**Addendum No. 2
Erie International Airport
Extend Taxiway A, Realign Taxiway D/G/F
Bid Package 1**

Project name: <u>Taxiway D/G/F – Bid Package 1</u>	Client: <u>Erie Regional Airport Authority</u>
Project location: <u>Erie, PA</u>	Client representative: <u>Kimberlie Sharrer</u>
Project number: <u>3225600-243123.02</u>	Mead & Hunt, Inc. Manager: <u>Byron Henicle</u>
Date: <u>May 27, 2026</u>	Mead & Hunt Inc. Phone: <u>971-256-9307</u>

Revised Sheets G-003, E-304, and E-305 are attached.

AIRFIELD SIGN SCHEDULE

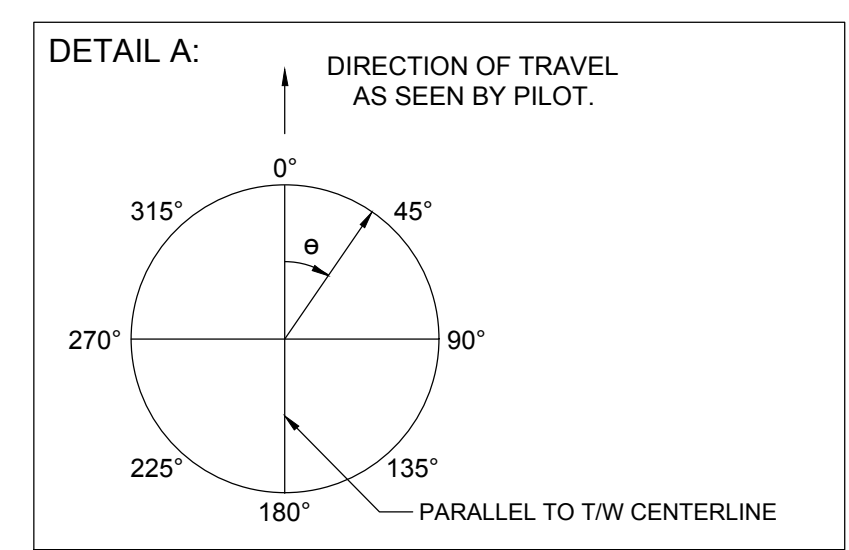
Q 7: Sign # 120 is listed as 3 modules on the sign schedule but the sign legend image only shows 1 module. It is the same on the sign layout too. Am I correct that 1 module is correct?

A 7: 1 module is correct, sign schedule has been updated to match sign legend and layout.
